Just wanted to make all aware that Nalcor is planning on posting the IE report (attached) today to their website. Cory, Walter and I have reviewed. It is ok – some observations below that may pick up some public attention. Understand that Nalcor has provided some key messages to NR.

MEETINGS IN ST. JOHN'S AND VISITS TO LOWER CHURCHILL PROJECT SITES, NOVEMBER 28 TO DECEMBER 01, 2016

Prepared for: Natural Resources Canada and Nalcor Energy
 IE Point of Contact: Nik Argirov
 Date: March 3, 2017

Figure 5.1: Upstream cofferdam zoning

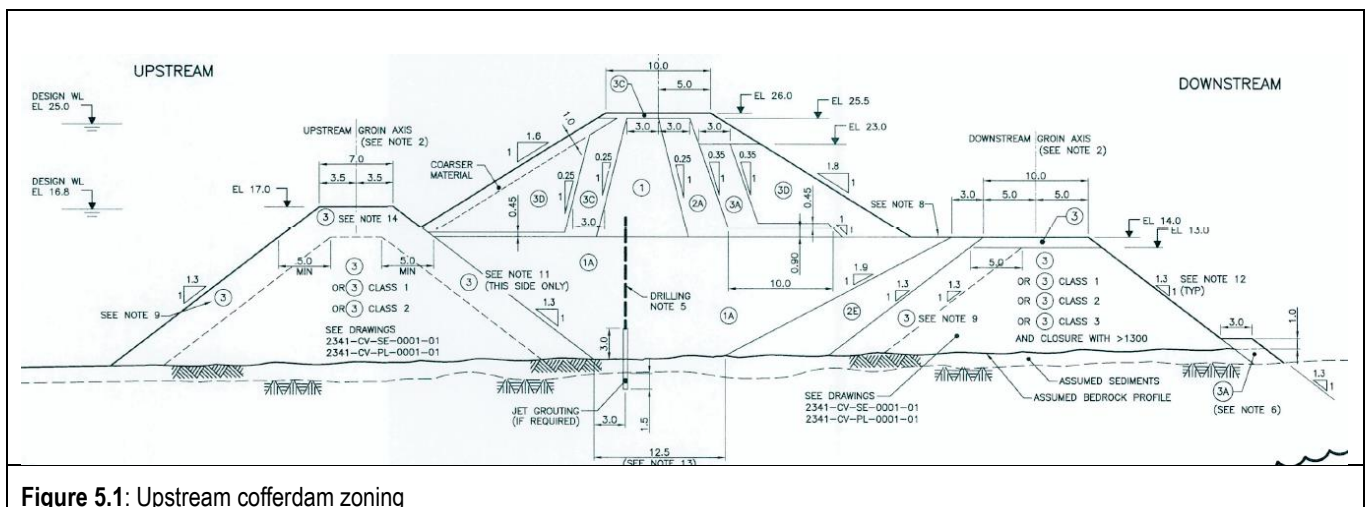
The Muskrat Falls Upstream cofferdam is a 450 m long embankment structure located upstream of the planned main RCC dam (Photo D.1). As originally designed and constructed it was about 26 m high and consists of lower dumped starter dam topped off by a compacted fill embankment dam, as shown on Figure 5.1 below and on Drawing MFA-SN-CD-2340-CV-SE-0002-01 Rev C2. As shown on the figure and the drawing, the starter dam consisted of two rock fill groins of 5 m to 12 m height, constructed from the riverbed up to el 14 m with a dumped till impervious zone placed in between them. Dumped transition rock fill zones were placed on the groin slopes, upstream and downstream of the impervious zone. Additionally, a granular filter zone will be sandwiched between the downstream impervious and transition zones. A 12 m high conventional center core embankment dam was then constructed on top of the starter dam up to el 26 m. The overall design of the cofferdam is conventional and in line with accepted practice.

The rockfill groins of the el 14 m starter dam were placed on the natural riverbed. Approximately 12.5 m wide at the base, the impervious fill zone was placed on the cleaned riverbed between the groins. Since the foundation between the groins could not be dewatered, final cleaning of the rock surface was carried out by backhoes operating from the tops of the groins. The impervious core till material was dumped through the water onto the machine cleaned foundation. No foundation grouting was carried out prior to raising the reservoir upstream of the cofferdam.

Figure 5.3: Cross-section of the upstream cofferdam. The areas outlined in red show the upstream rockfill addition, the 1.0 m crest raising fill and el 17 m downstream weighting zone above the el 14.0 m downstream groin.

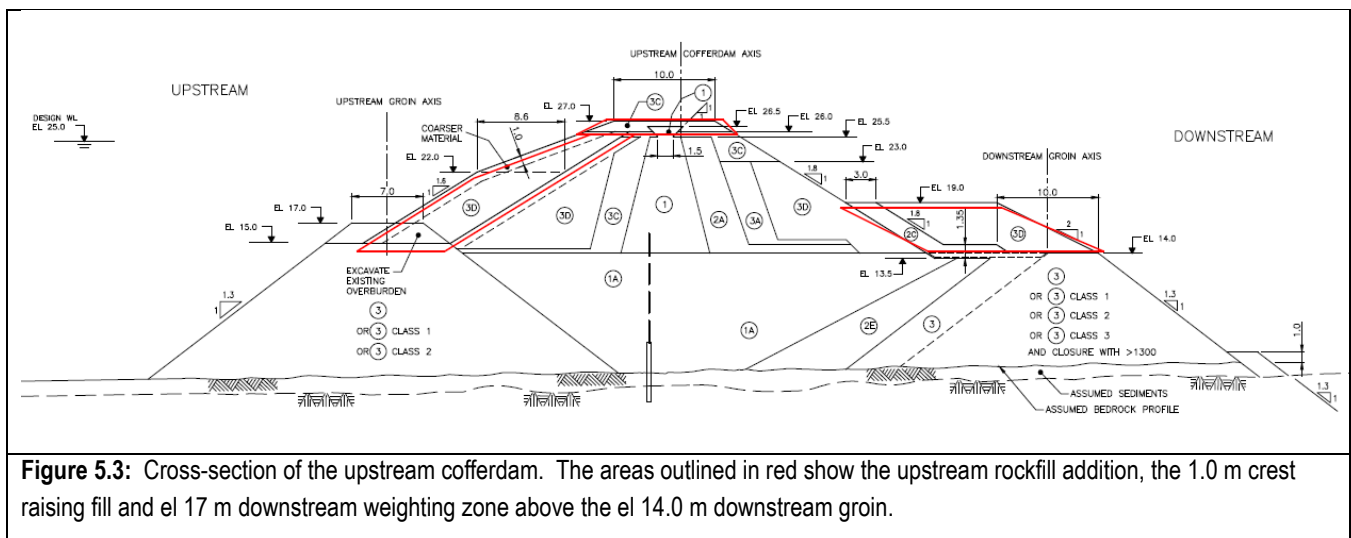
The IE concurs with these objectives and believes that they would repair the damage and reduce the risk of future leakage damage. This is a “belt and braces” approach which is appropriately conservative. Remedial works are focusing on the area between Sta 280 to Sta 400. By the time of the IE site visit a number of remedial construction works (shown on Figure 5.3) had been completed:

The IE concurs that the planned grouting will repair defects in the core, foundation contact zone and upper bedrock. The IE suggested in the SNC meeting on December 1 that additional downstream holes be drilled to form local cells in localized spots where there are high grout takes. The IE also notes that compaction grouting may not seal washed granular zones in the core that were created by the November leakages. Some permeation grouting with plastic-low strength mixes may be beneficial in the core. Similar permeation grouting was used to repair damaged impervious till cores of the Upper Churchill dykes in the late 1970's and the Long Pond Dam in Bay D'Espoir in the late 1980's.

At the time of the IE site visit, the project engineers were finalizing details of the grouting repairs to the core and foundation. A contract had been let and a drill/grout rig was enroute to the Muskrat Falls site. Planned grouting works were being designed to; (a) repair the damaged core, (b) inject grout into possibly permeable zone at the base of the fill, i.e. at the top of the bedrock, and (c) inject grout into open fractures in the upper bedrock zone. These three grouting objectives require different grout mixes and techniques. The planned grouting program will deal with this in the following way:
